**RE: Beer Garden at Stapleton
Site Plan and Conditional Uses**
Response to 2nd Review Comments

Following are responses to comments issued by the City of Aurora on October 21, 2019 for the proposed Beer Garden at Stapleton (the "Project") located at 2323 Dayton Street.

BEER GARDEN @ STAPLETON
2323 DAYTON,
AURORA, COLORADO

SITE PLAN AND CONDITIONAL USES

COVER

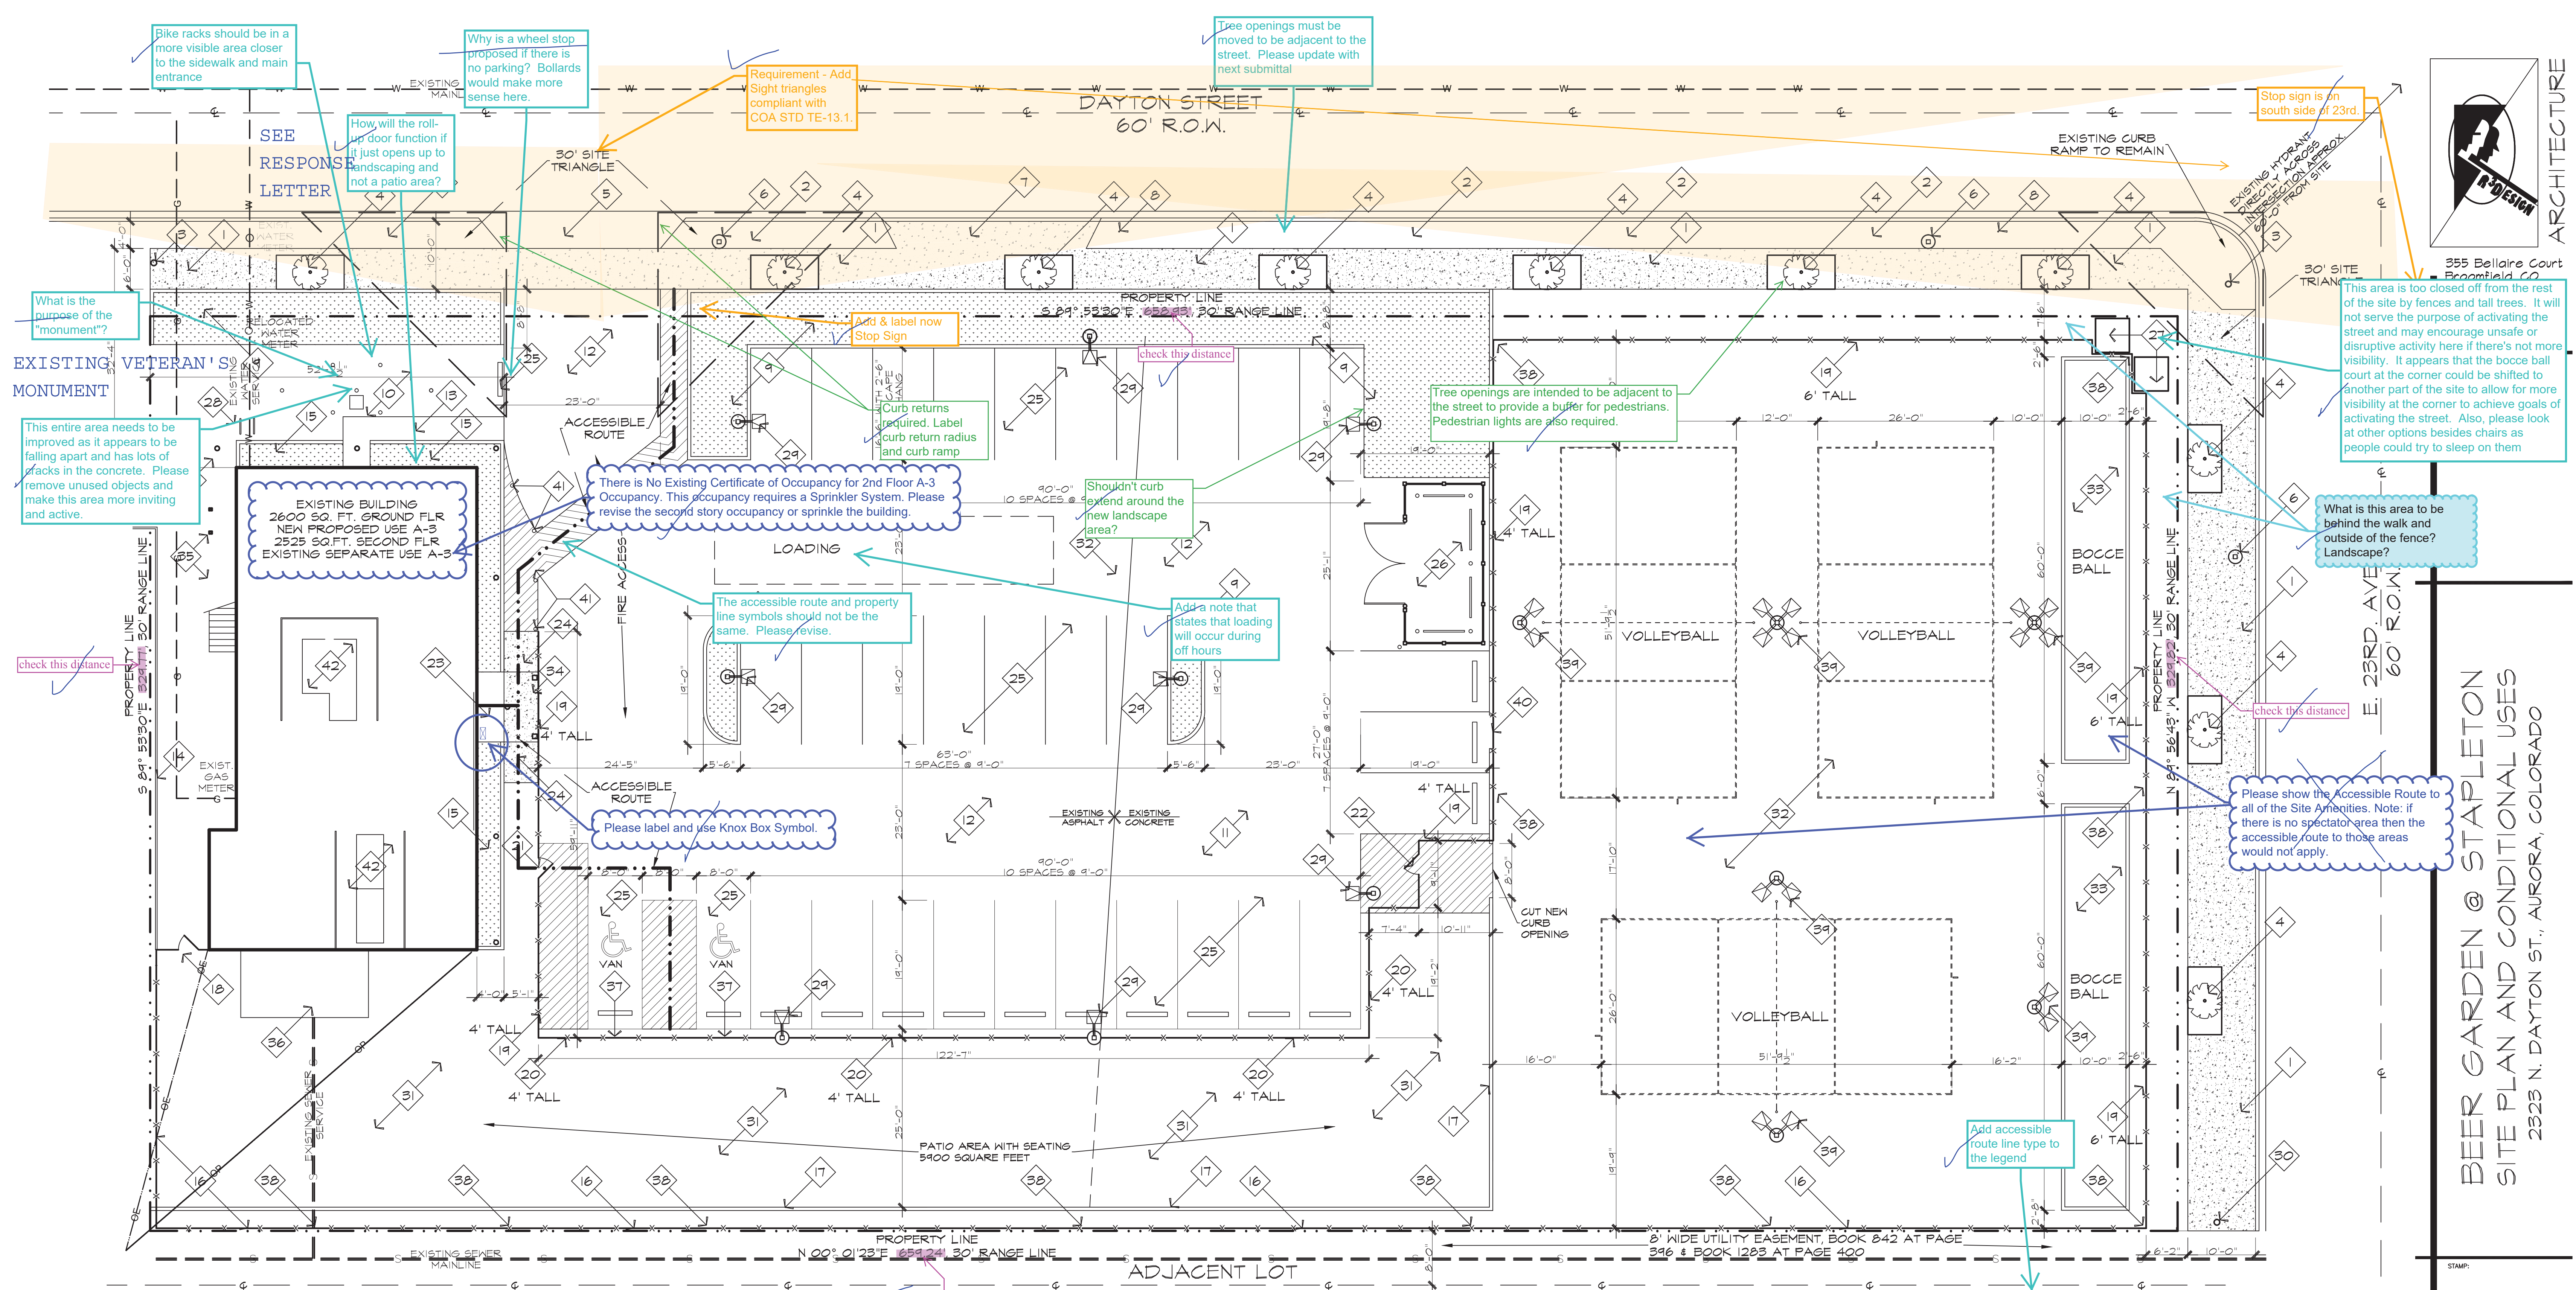
Note #18 is NOT acceptable to the city and must be removed. The note should state that the applicant will comply with the maximum noise standards in Section 4.11.2(E). This applies to all properties in the city and cannot be modified

4. VICINITY MAP SHOULD BE IN BLACK AND WHITE. ALSO, THE OUTLINE AROUND THE SITE NEEDS TO BE BOLDER AS IT'S DIFFICULT TO SEE.
5. EXTERIOR ROUTES" SHALL BE PROVIDED FROM PUBLIC TRANSPORTATION STOPS, PARKING, ACCESSIBLE PASSENGER LOADING ZONES AND PUBLIC SIDEWALKS TO 60% OF ALL BUILDING ENTRANCES THEY SERVE. THE ACCESSIBLE ROUTE BETWEEN ACCESSIBLE PARKING AND ACCESSIBLE BUILDING ENTRANCES SHALL BE THE MOST PRACTICAL DIRECT ROUTE. THE ACCESSIBLE ROUTE MUST BE LOCATED WITHIN A SIDEWALK. NO SLOPE ALONG THIS ROUTE MAY EXCEED 1:20 WITHOUT PROVIDING A RAMP WITH A MAXIMUM SLOPE OF 1:12 AND HANDRAILS. CROSSWALKS ALONG THE ROUTE SHALL BE WIDE ENOUGH TO WHOLLY CONTAIN THE CURB RAMP WITH A MINIMUM WIDTH OF 36", AND SHALL BE PAINTED WITH WHITE STRIPES. THE CITY OF AURORA ENFORCES HANDICAPPED ACCESSIBILITY REQUIREMENTS BASED ON THE 2015 INTERNATIONAL BUILDING CODE, CHAPTER 11, AND THE AMERICAN NATIONAL STANDARDS INSTITUTE (ICC/ANSI) A117-2009.

12. THERE IS NO EXISTING CERTIFICATE OF OCCUPANCY FOR 2ND FLOOR A-3 OCCUPANCY. THIS OCCUPANCY REQUIRES A SPRINKLER SYSTEM. PLEASE REVISE THE SECOND STORY OCCUPANCY OR SPRINKLE THE BUILDING.

13. EASEMENTS MUST BE FULLY ACCESSIBLE ALONG THEIR ENTIRE LENGTH TO ALL UTILITIES. PLEASE USE "ACCESSIBLE" NOT ADA. THE OPERATION OF UTILITY LINES PLACED WITHIN THE EASEMENT BY SUBMITTING THESE SITE OR CONSTRUCTION PLANS FOR APPROVAL, THE LANDOWNER RECOGNIZES AND ACCEPTS THE TERMS, CONDITIONS & REQUIREMENTS OF THIS NOTE.

22. WHERE APPLICABLE AND NECESSARY, DEVELOPER SHALL PLACE TRAFFIC CONTROL SIGNS, STREET NAME SIGNS, AND GUIDE SIGNS ON ALL ADJACENT PUBLIC STREETS.
23. REMOVE "OF 10" FROM ALL SHEETS
